Administrative Action Preliminary Subdivision

Case File / Name: S-49-15 / Idlewood Village

Nature of Case: Subdivision of 11.6 acres into 39 single-family detached lots and 3 open space lots zoned Residential-6.

OFFICIAL ACTION: **Approval with conditions**

Subdivision Layout

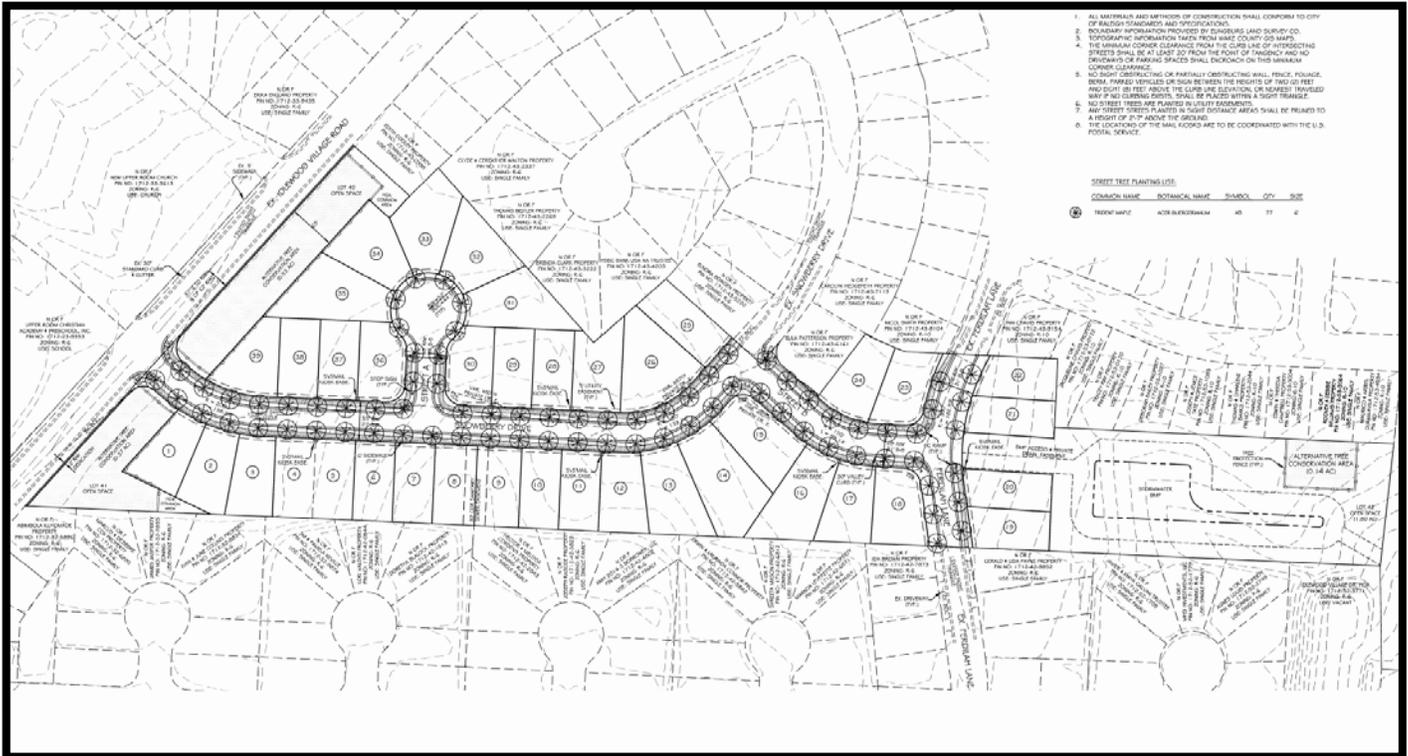
CONDITIONS OF APPROVAL:

- (1) That a final tree conservation plan with permit be approved by the Forestry Specialist. The plan must show metes and bounds descriptions of all tree conservation areas, and tree protection fence around all tree conservation areas. Tree protection fence must be located in the field and inspected by the Forestry Specialist;
- (2) That in accordance with Part 10A Section 9.4.4, a surety equal to of the cost of clearing, grubbing and reseeding a site, shall be paid to the City;

- (3) That a final tree conservation plan with permit be approved by the Forestry Specialist. The plan must show metes and bounds descriptions of all tree conservation areas, and tree protection fence around all tree conservation areas;

- (4) That a nitrogen offset payment must be made to a qualifying mitigation bank;
- (5) The NCDOT driveway permit and encroachment approvals for Idlewood Village Drive will be required prior to infrastructure construction drawing mylar signatures and prior to map recordation;

- (6) That a stormwater control plan with a stormwater operations and maintenance manual and budget shall be approved by the Stormwater Engineer in compliance with Part 10A Chapter 9 of the Unified Development Ordinance, including the designation of buffer areas and open space areas for stormwater purposes prior to grading or the approval of construction drawings whichever event comes first;

- (7) That a tree conservation plat be recorded with metes and bound showing the designated Tree Conservation Areas and shall be in compliance with Chapter 9 of the Unified Development Ordinance;

- (8) That Infrastructure Construction Plans are approved by the City of Raleigh, including obtaining stub permits, tree impact permit and a street lighting plan

- (9) That a fee-in-lieu for 1' sidewalk on Idlewood Village Drive will be required prior to map recordation;
- (10) That the surety for public improvements will be construction costs at 100% for Idlewood Village Drive and 125% for the 4 remaining streets (City) and will be required prior to map recordation;

- (11) That street names for this development be approved by the City and by Wake County;
- (12) That in accordance with Part 10A Section 9.2.2, a surety equal to 125% of the cost of the construction of a stormwater device is paid to the Public Works Department;

- (13) That the developer shall pay to the City a stormwater facility replacement fund payment equal to twenty-four percent (24%) of the estimated cost of constructing all stormwater control facilities shown on the development plans;

- (14) That the City form document entitled Declaration of Maintenance Covenant and Grant of Protection Easement for Stormwater Control Facilities shall be recorded with the county register of deeds office where the property is located prior to any recordation of a subdivision or recombination plat and a copy of the recorded documents be provided to the Planning Department within the 14-day period, further recordings and building permits authorization will be withheld if the recorded document is not provided to the Planning Department; Required legal documents shall be recorded within 1 day of the approval of a recorded map, if applicable;

- (15) That all stormwater control measures and means of transporting stormwater runoff to and from any nitrogen and stormwater runoff control measures shall be shown on all plats for recording as private drainage easements and the plats shall contain the following note: "All private storm drainage easements & stormwater measures will be maintained by the homeowner association".
